Cortina Systems[®] LXT9785/LXT9785E Advanced 8-Port 10/100 Mbps PHY Tranceiver

Specification Update

Document Number 249357

Revision 13.0

Erratum 17: Detection of Illegal Symbols After SSD

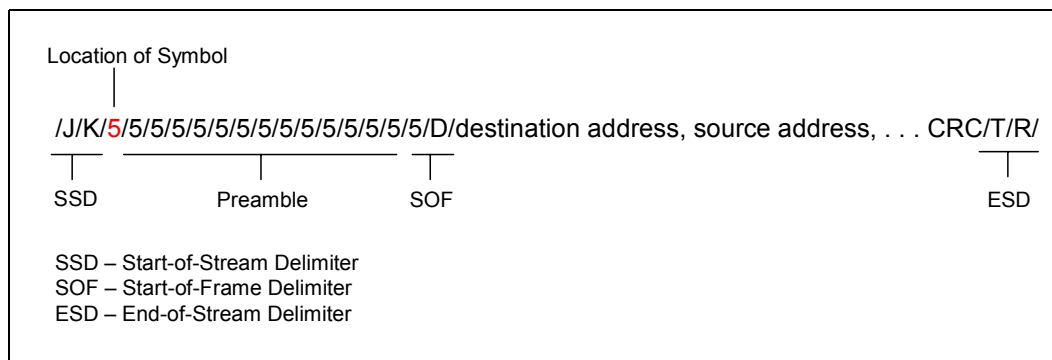
- Problem** An illegal symbol placed immediately after the SSD (preamble after JK) is not detected. However, any subsequent corrupt symbol will be detected. Below is the standard frame contents:

- Implication** RXER will not assert if this symbol location is corrupted. However, an error in this location does not affect packet integrity.
- Workaround** Use the MAC layer protocol to detect corrupt symbols in the packet.
- Status** No Fix

Erratum 21: False Carrier Over-Extension

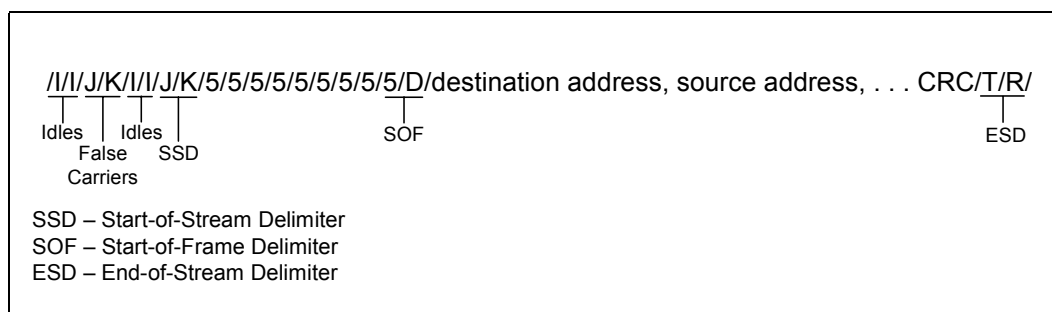
Problem A false carrier event, followed by two idle symbols and a packet, may extend the false carrier event to include the packet in 100 Mbps operation. This false carrier sequence is shown in the false carrier diagram below.

Implication A packet may be seen as a false carrier event and may be dropped. Minimal impact is expected. False carriers occur only when a large number of errors occur due to poor link quality. Below is a diagram of a false carrier:

Workaround None.
